From: Sara Roediger, AICP
 Date: 3/9/2016
 Re: **Jenoptik**
Preliminary/Final Site Plan - Planning Review #1

**RE: Jenoptik Automotive N.A.
Parcel #15-21-376-011
City File #16-002
Preliminary Site Plan Review**

From: Jason Boughton, AC *JRB*
To: Sara Roediger, Manager of Planning
Date: March 9, 2016
Re: Jenoptik Automotive Building, City File #16-002, Section #21, **Site Plan Review #1**

CITY OF ROCHESTER HILLS
STANDARD DETAIL FOR:
Sight Distance Roadways

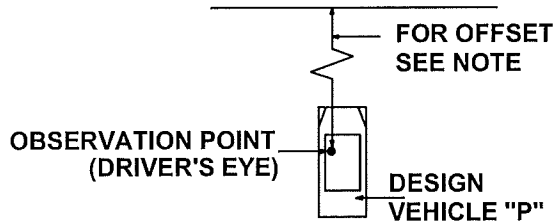
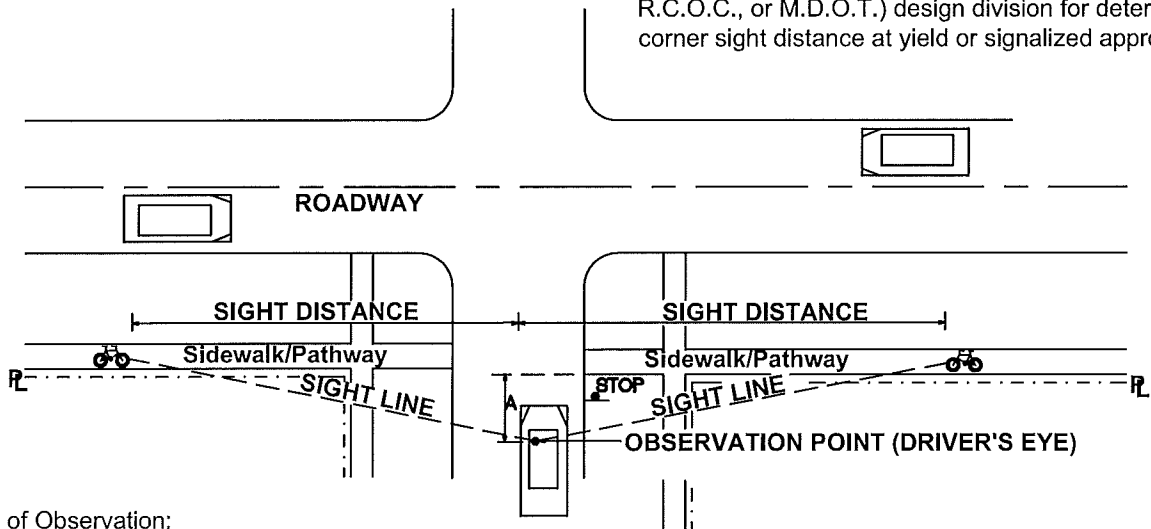
1. On sheet L-1.1, indicate the road traffic safety sight lines per the attached detail for a 45 MPH road.

- 12) The road traffic safety sight lines will be added to the landscape plans as requested.

CITY OF ROCHESTER HILLS
 STANDARD DETAIL FOR:
 Sight Distance Pathways

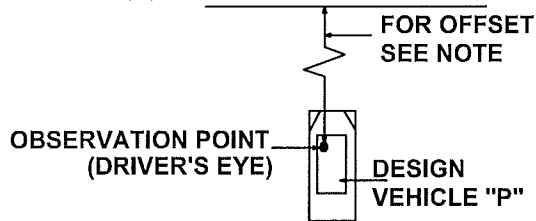
1. On sheet C-7.1, the asphalt path detail should be 2.5 inches thick for the leveling course. Alternately, since the areas of asphalt path work are minimal these areas may be replaced with 4 inch concrete pavement.
2. On sheet C-7.1, include note on concrete sidewalk detail that ramps and landing shall be 6 inch thick concrete.
3. On sheet L-1.1, indicate the path sight lines per the attached detail. Use 150 feet. It appears the Greenspire Linden on the north and south sides of the north driveway approach may be within limits. Also, the 2 Sugar Tyme Crab trees appear to be within the sight distance limits along south side of same drive. The Red Oak along the north side of southerly driveway approach appears to be within the sight distance line. It appears these trees could easily be shifted north to avoid sight lines.

- 10) The requested note regarding the concrete sidewalk thickness at ramps and landings shall be 6 inch thick will be added to the plans.
- 11) The path sight lines will be added to the landscape plan and the trees will be adjusted, as necessary.

Existing Water Main for Jenoptik Automotive #16-002

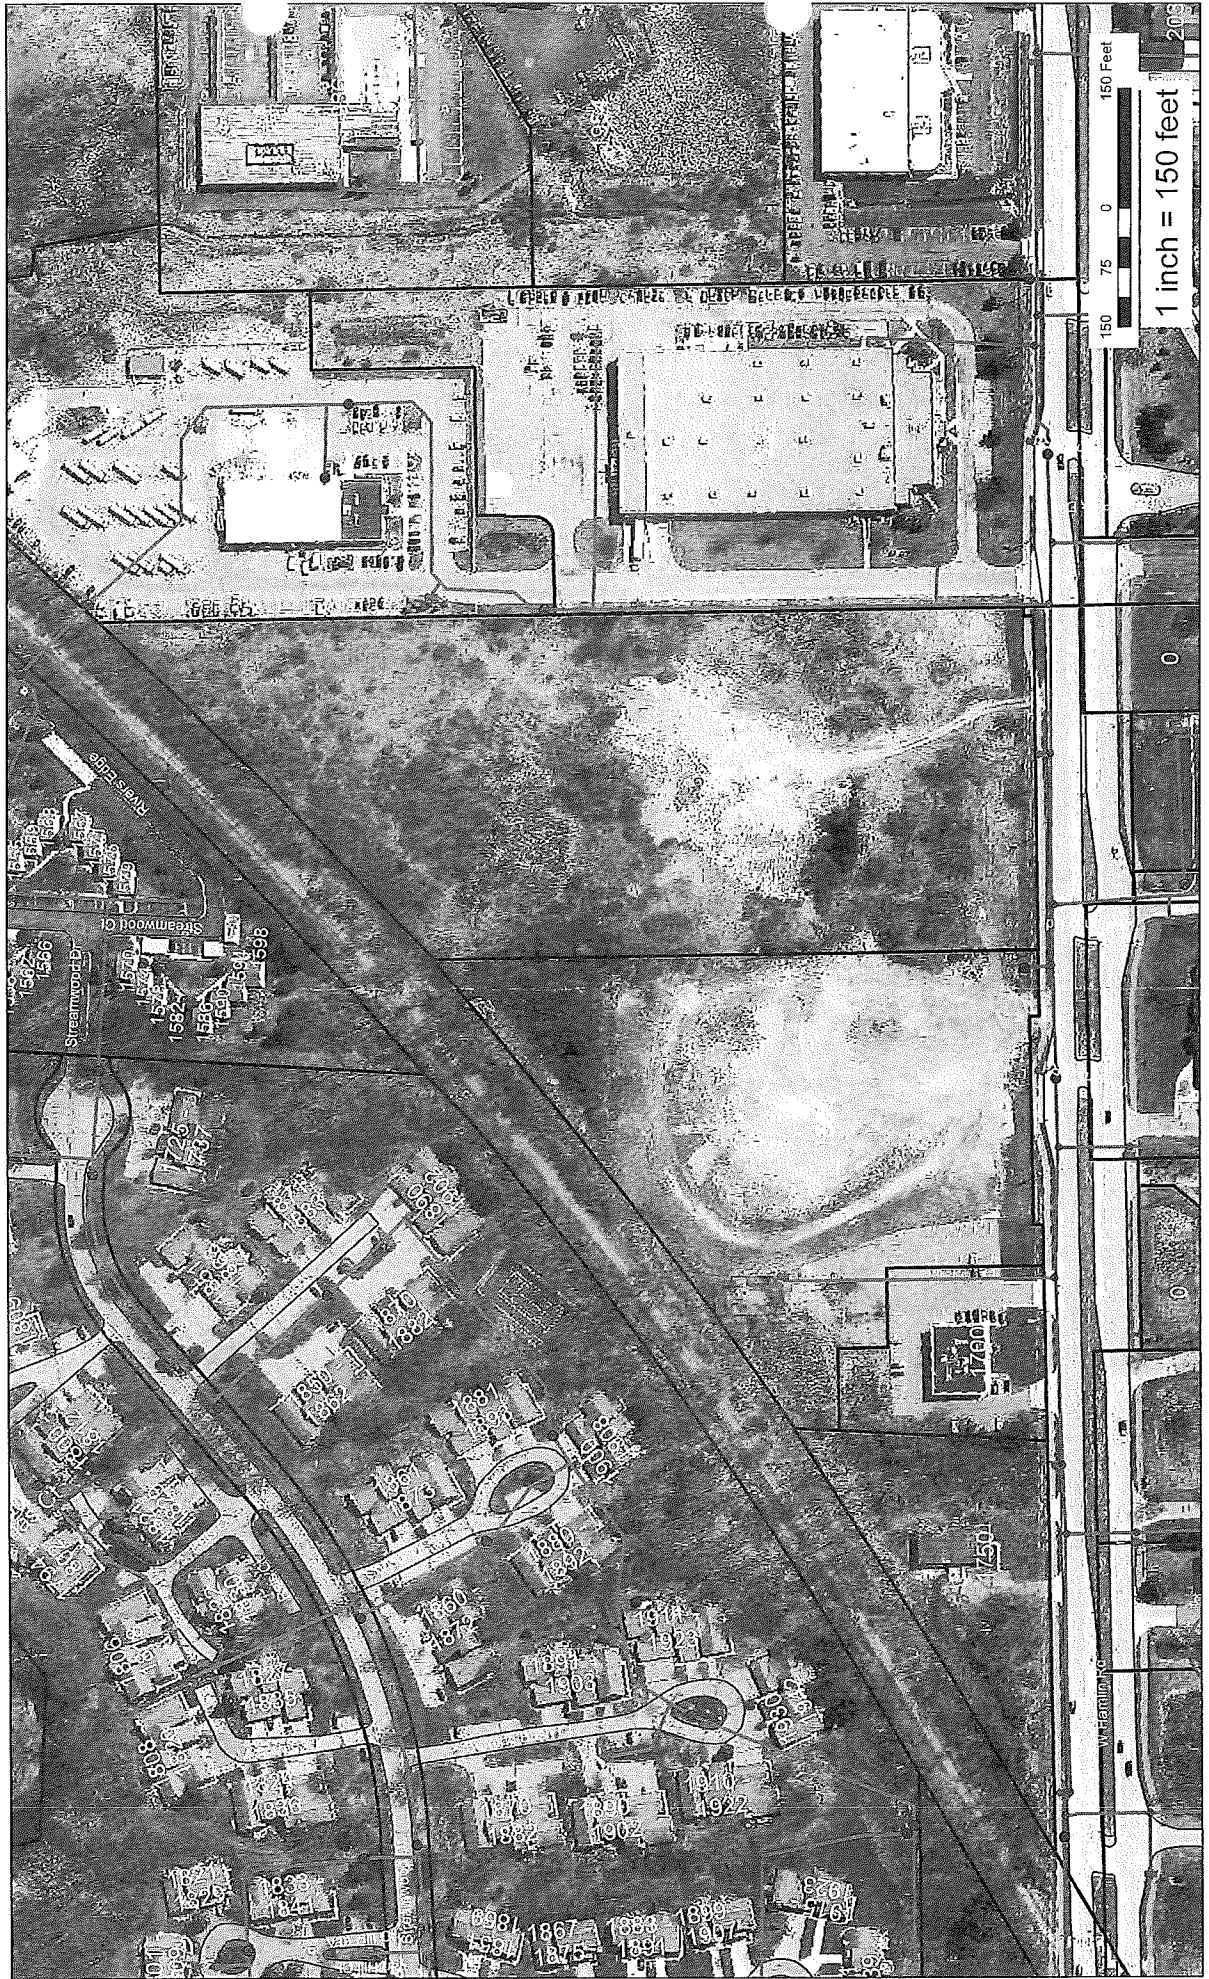
1. Show the sizing and location of the proposed water service for the building.
2. Revise the location of the west water main connection as shown on the provided GIS map.
3. Provide an additional water main basis of design for the phase 2 portion of the project.
